Re: East Lincoln Drive South Development Area; Smoke Tree Resort; Lincoln Medical Plaza
Effect on Adjacent Residential & Non-Residential Properties – Street Issues

Re: Paradise Valley East Lincoln Drive South Development Area Work Session – Sept. 13
 Major Special Use Permit Amendment (SUP-18-05) - Smoke Tree Resort
 Major Special Use Permit Amendment (SUP-18-06) - Lincoln Medical Plaza
 Effect on Adjacent Residential Properties

EXHIBIT B

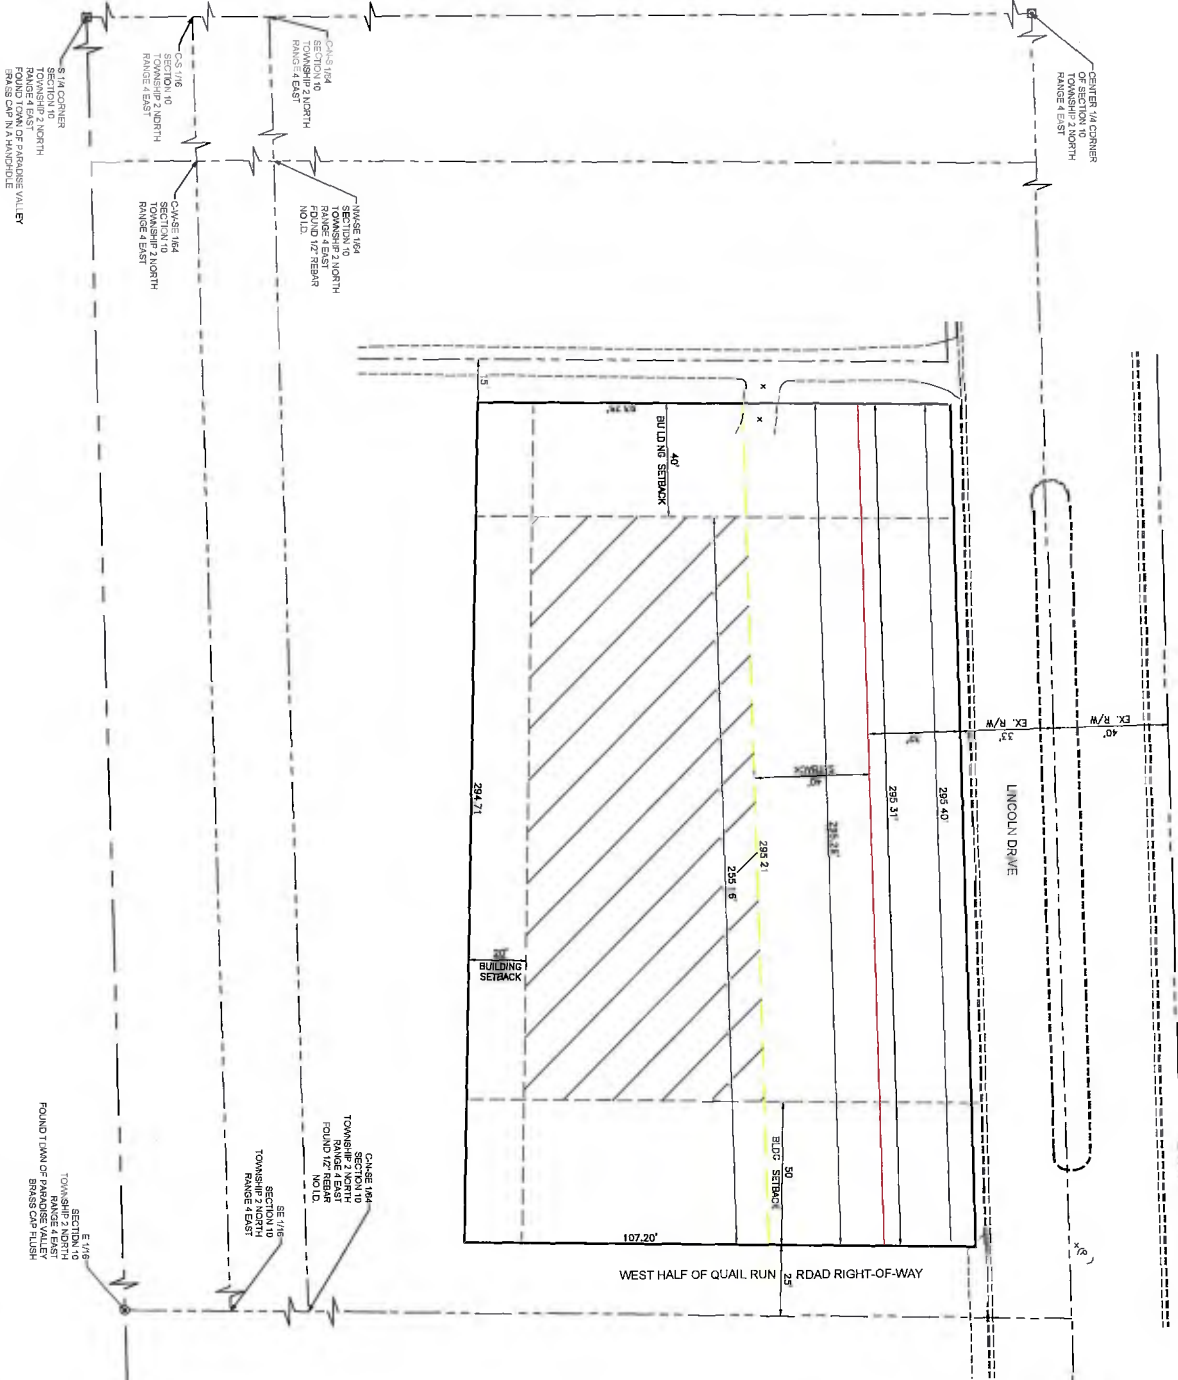
It's understood that Smoke Tree has resisted proposed changes to the existing access points and dedicating anything for streets as effectively shrinking the developable area of its property. In contrast, please see the diagrams attached as Exhibit B and Exhibit C and consider the impact on the neighboring residential property. Exhibit B depicts the current setback situation on the SunChase lot at the southwest corner of Lincoln and Quail Run. That lot is currently improved with a single-family home that is set back 52 feet from the existing Lincoln right-of-way. Exhibit C then depicts how the developable area of that lot is reduced by a number of potential additional setbacks that would impact any new construction. (1) The currently proposed Lincoln widening is an additional 32 feet (20 feet from the current residence). (2) Depending upon whether a new residence faced Lincoln or Quail Run, the front or side yard setback would be at least 40 feet from the widened Lincoln. (3) In either orientation, there is a recorded 50 feet setback required from Quail Run. (4) And in either orientation, there is another 40 feet setback from the rear and a 20 feet setback on the remaining side. (5) After the above points 1-4, the developable area that is left could be approximately $\frac{1}{3}$ acre, for an R43 zoned lot. Now, consider the exacerbating effect that along with Smoke Tree's proposal to further burden the half-street Quail Run, but not to dedicate its 25 feet, and to improve its property within that non-dedication area, it proposes to add two access points there. So, again, SunChase would like to know what the Town can do and proposes to do to address or otherwise protect the existing residential neighborhood adjacent to Smoke Tree.
